Product Change Notification

ECNS26-005
August 26, 2026
EM Devices Corporation

Change used materials of signal relay.
Relay Type: EA2, EB2, EC2, EE2 Series

1. Operate & release voltages

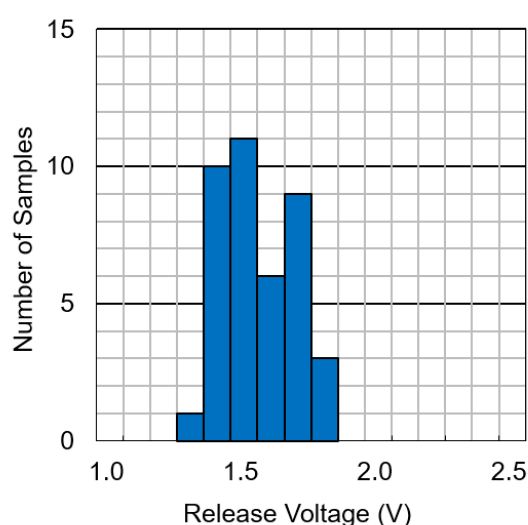
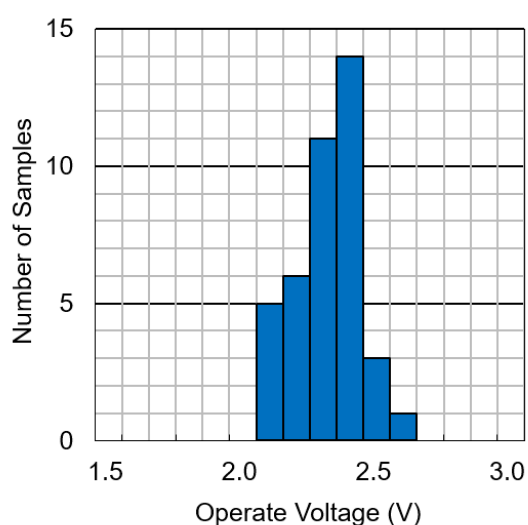
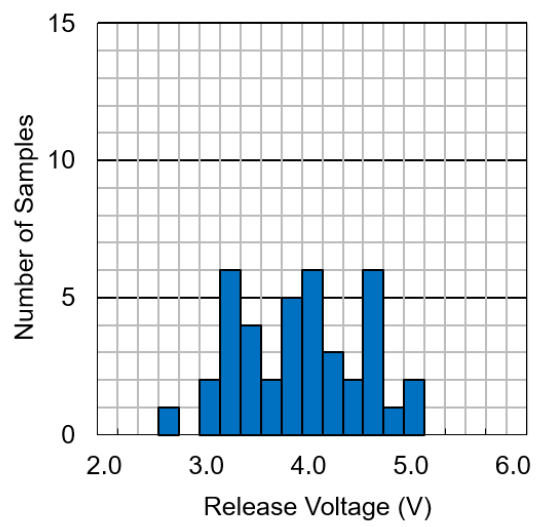
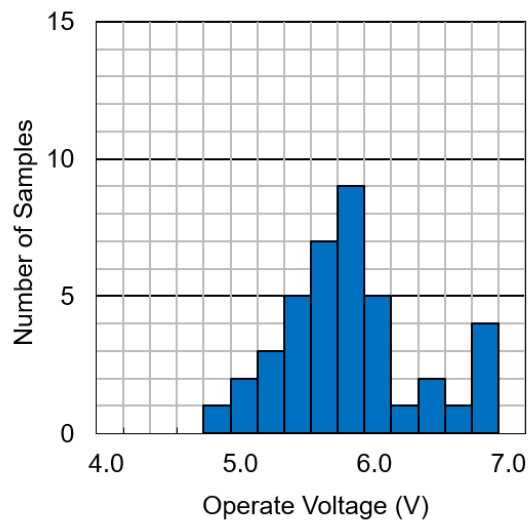
This section shows the distribution of the voltage at which the relay operates. The initial specifications are as follows.

Operate Voltage: 75% or less of Nominal Voltage (5-V type: 3.75V, 12-V type: 9.0V)

Release Voltage: 10% or more of Nominal Voltage (5-V type: 0.5V, 12-V type: 1.2V)

(1) Current (Sm-Co magnet), Non-latching, 5-V type

(2) New (Fe-Cr-Co magnet), Non-latching, 5-V type

(3) Current (Sm-Co magnet), Non-latching, 12-V type

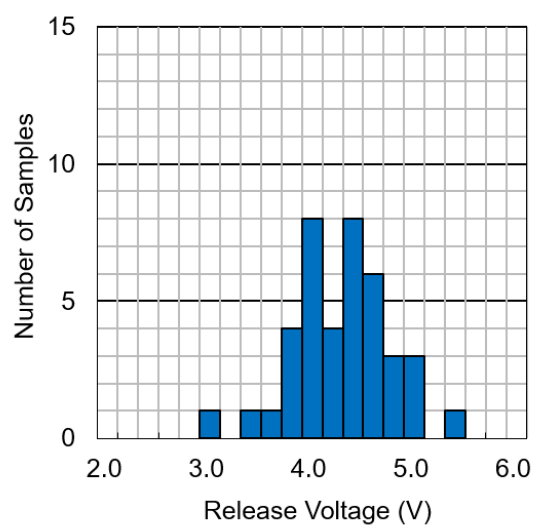
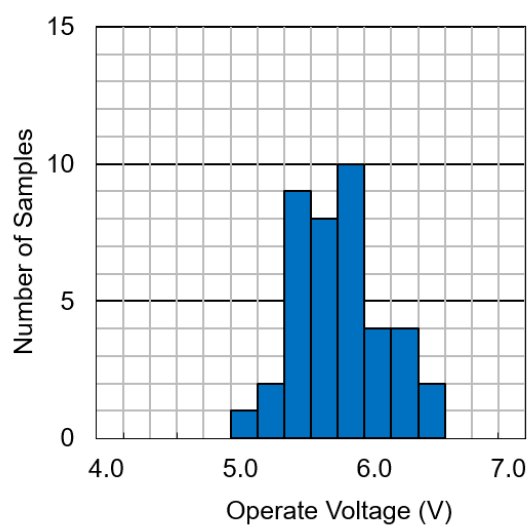
(4) New (Fe-Cr-Co magnet), Non-latching, 12-V type

2. Operate & release times (with bounce time)

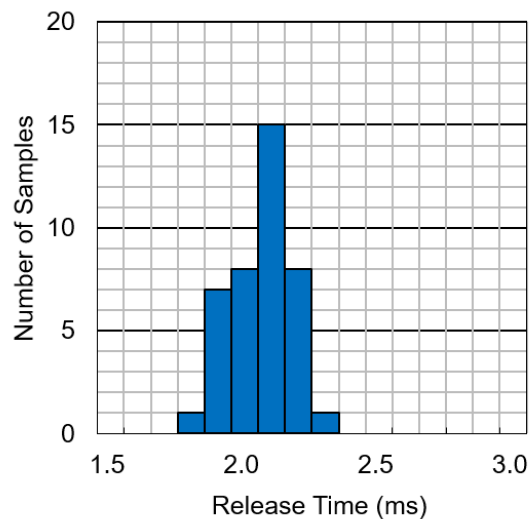
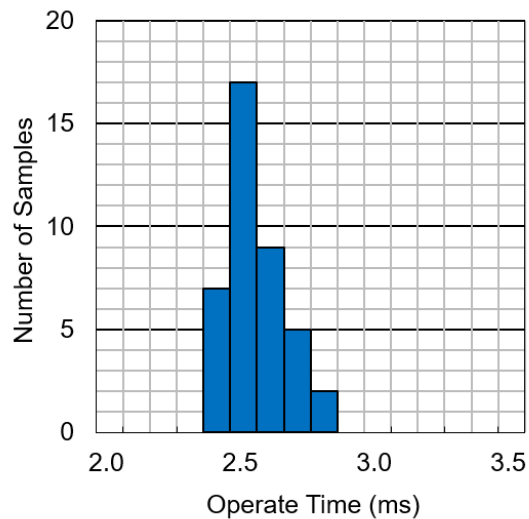
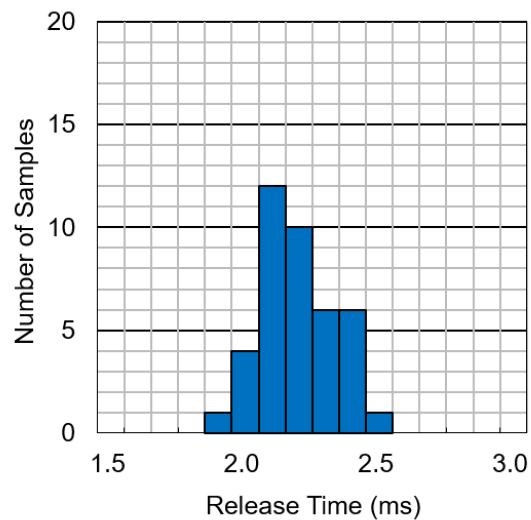
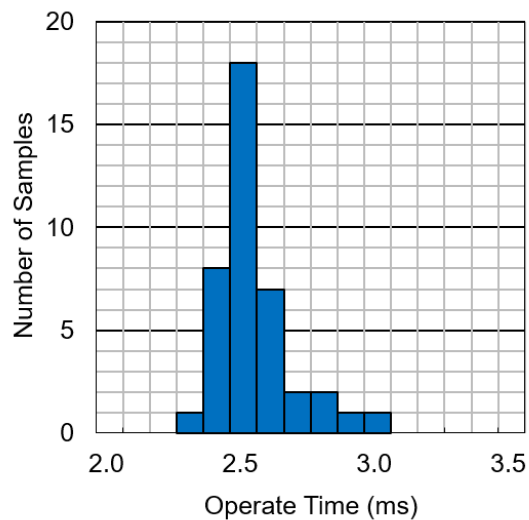
This section shows the operate time that elapses from the time when the relay coil is energized until the relay contacts close, and the release time that elapses from the time when the relay coil is deenergized until the closed contacts open. This data was measured with a diode added in parallel with the coil to prevent a counter electromotive force. This timing data shows the greater values of the two sets of contacts.

(1) Current (Sm-Co magnet), Non-latching, 5-V type

(2) New (Fe-Cr-Co magnet), Non-latching, 5-V type

(3) Current (Sm-Co magnet), Non-latching, 12-V type

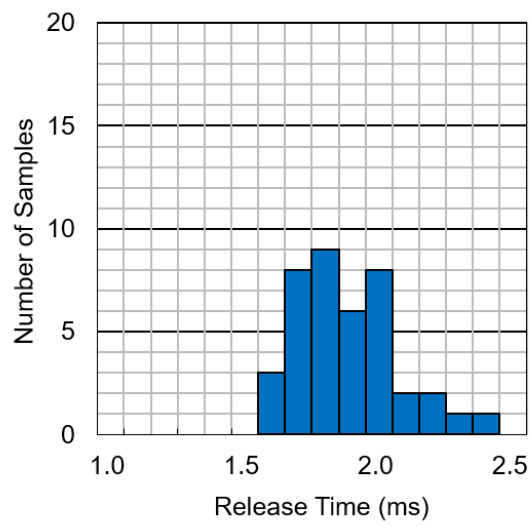
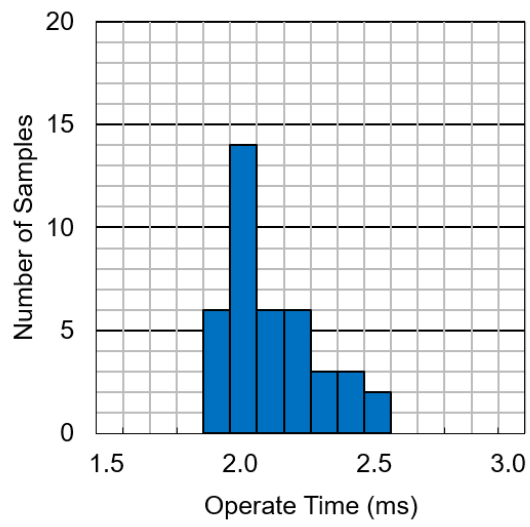
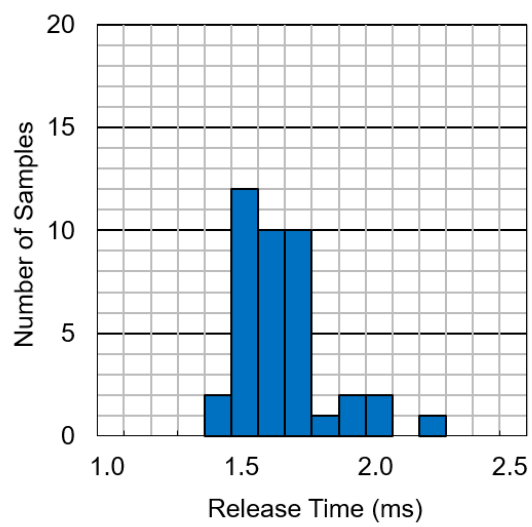
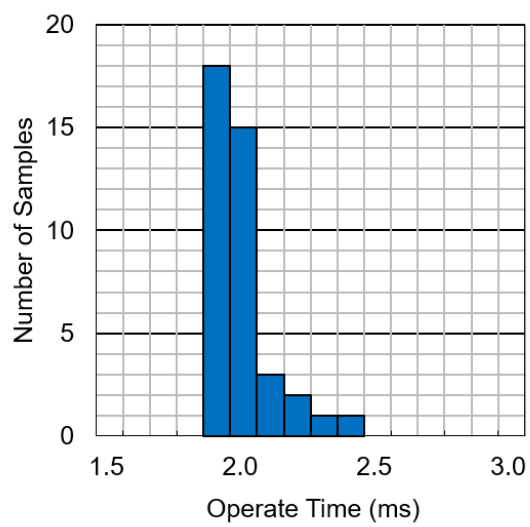
(4) New (Fe-Cr-Co magnet), Non-latching, 12-V type

3. Transfer time

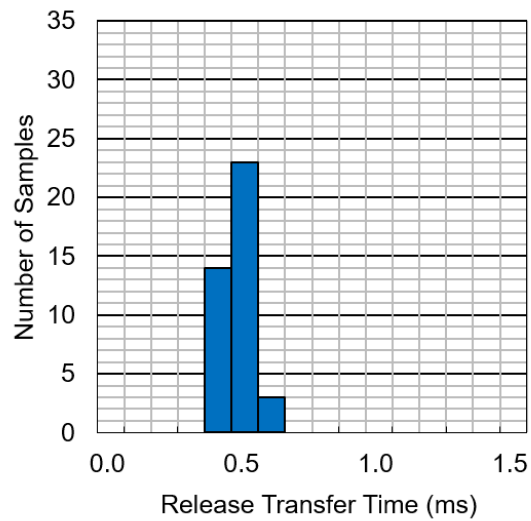
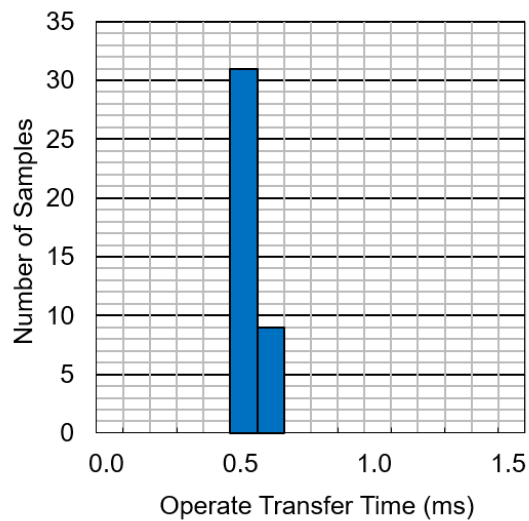
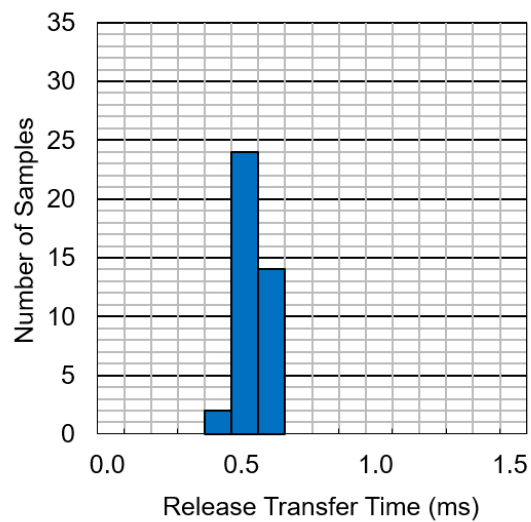
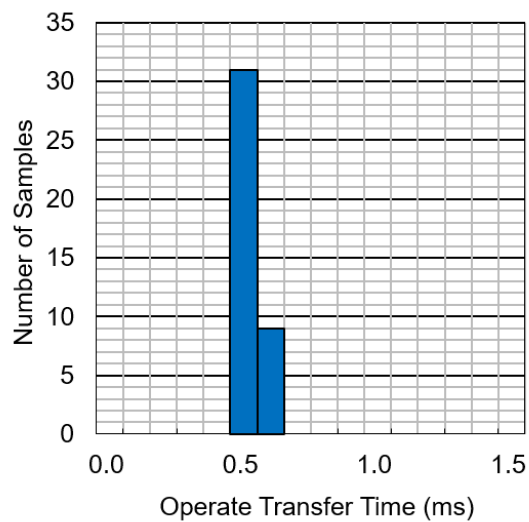
This section gives data on the transfer time, which is the total time between the breaking of one set of contacts and the making of another. This data was measured with a diode added in parallel with the coil to prevent a counter electromotive force. This timing data shows the smaller values of the two sets of contacts.

(1) Current (Sm-Co magnet), Non-latching, 5-V type

(2) New (Fe-Cr-Co magnet), Non-latching, 5-V type

(3) Current (Sm-Co magnet), Non-latching, 12-V type

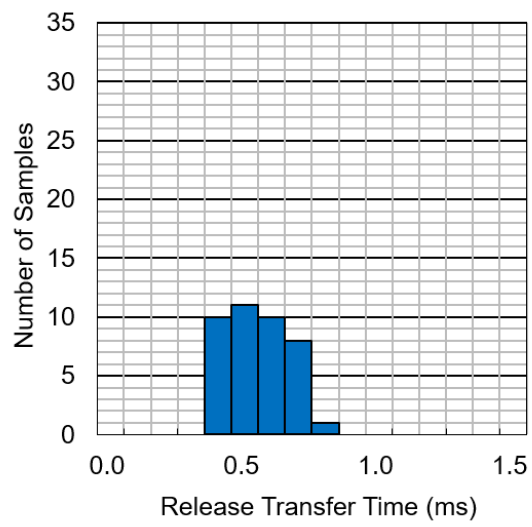
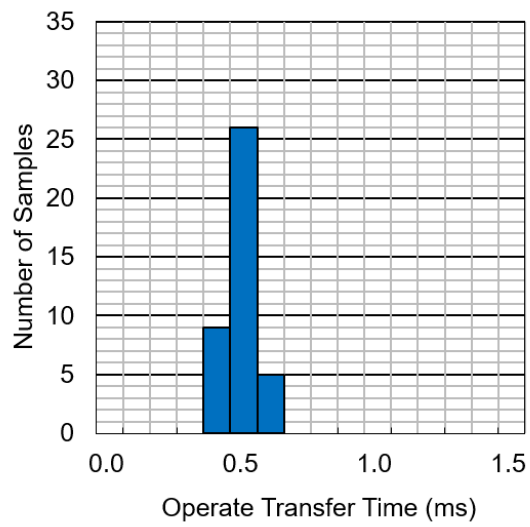
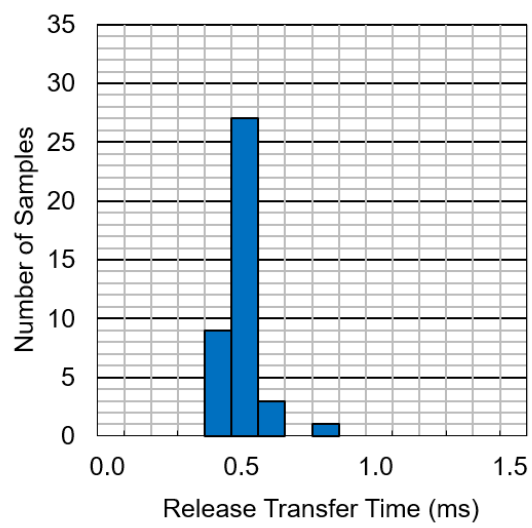
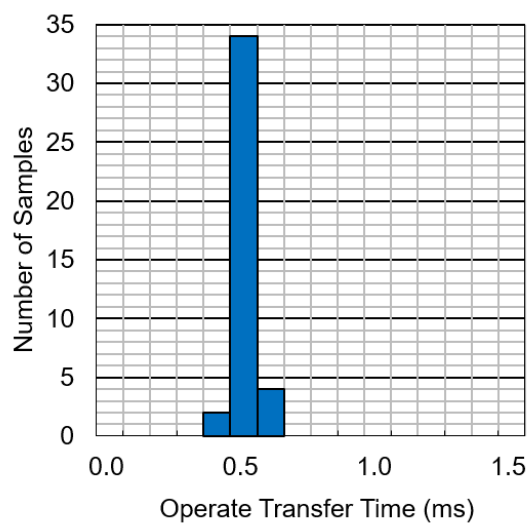
(4) New (Fe-Cr-Co magnet), Non-latching, 12-V type

4. Contact resistance

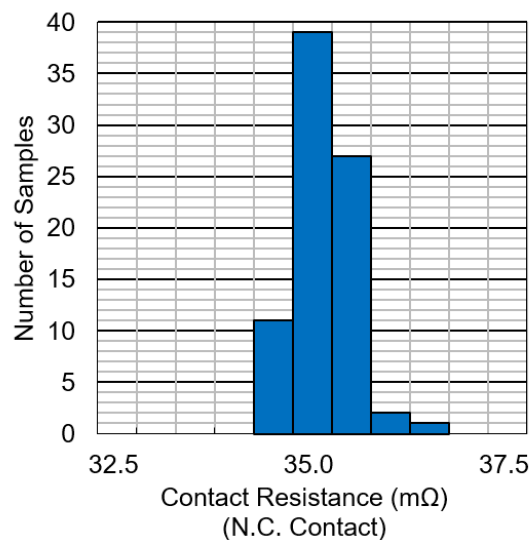
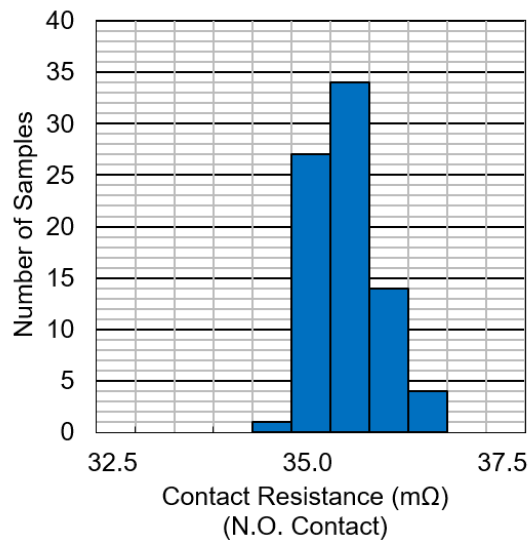
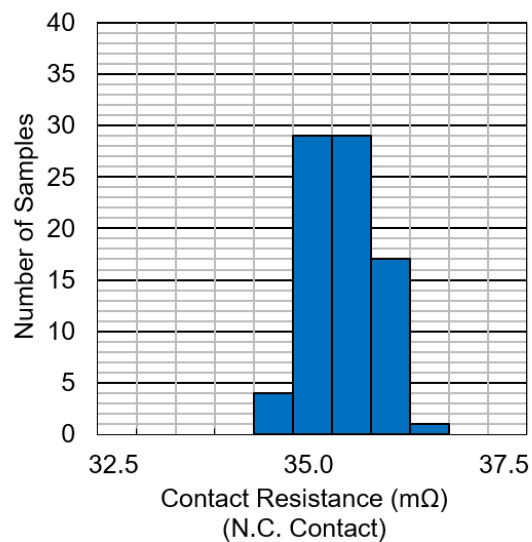
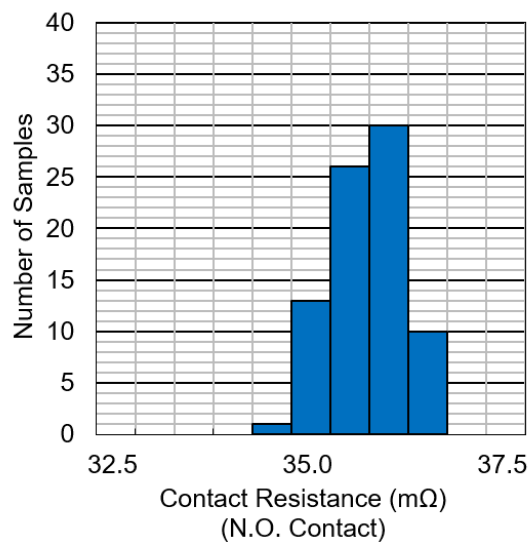
This section gives data on the resistance of the contacts when the contacts are closed. Since each relay consists of two sets of contacts, the total number of samples is 80. The initial specifications are as follows.

Contact Resistance: 75 m Ω or less

(1) Current (Sm-Co magnet), Non-latching, 5-V type

(2) New (Fe-Cr-Co magnet), Non-latching, 5-V type

(3) Current (Sm-Co magnet), Non-latching, 12-V type

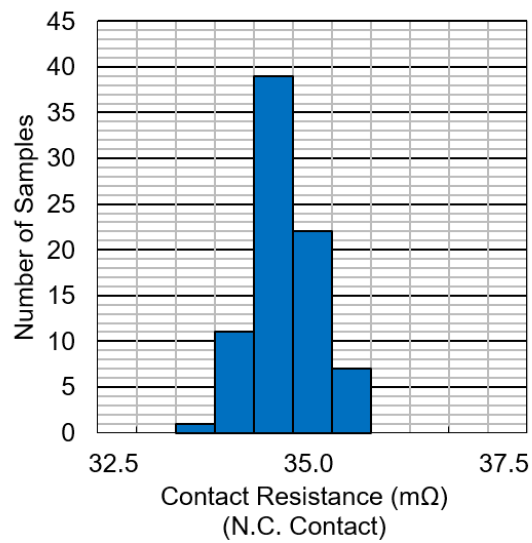
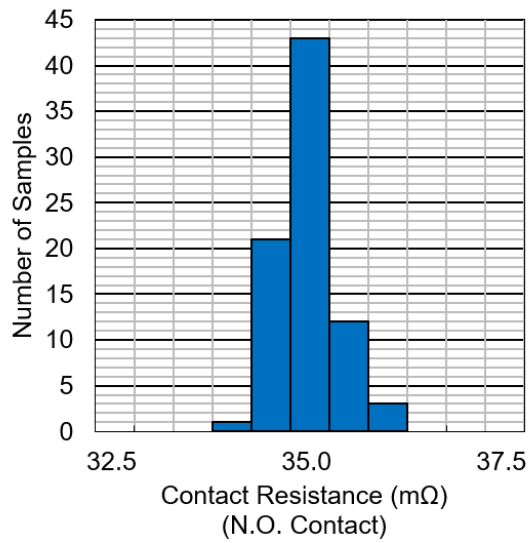
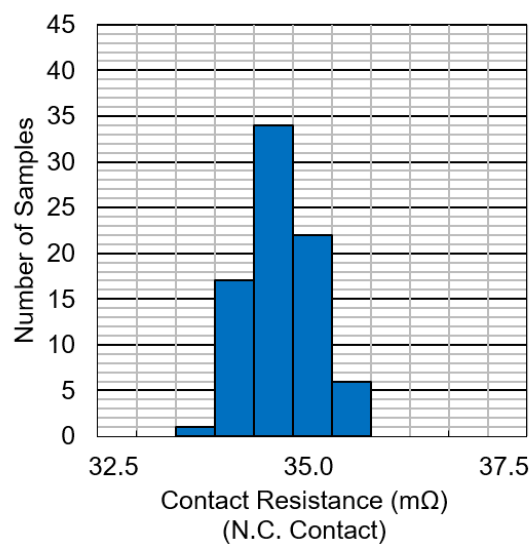
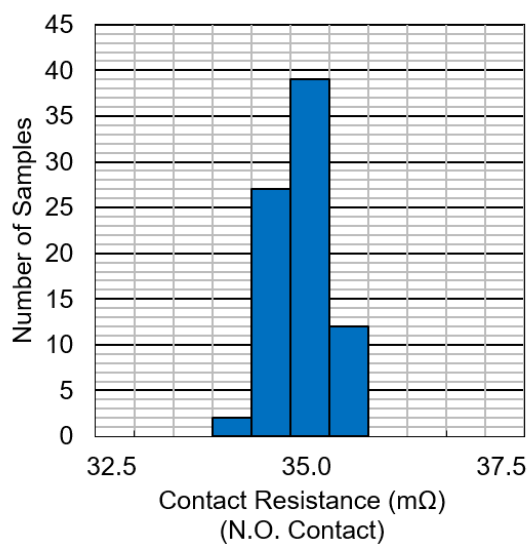
(4) New (Fe-Cr-Co magnet), Non-latching, 12-V type
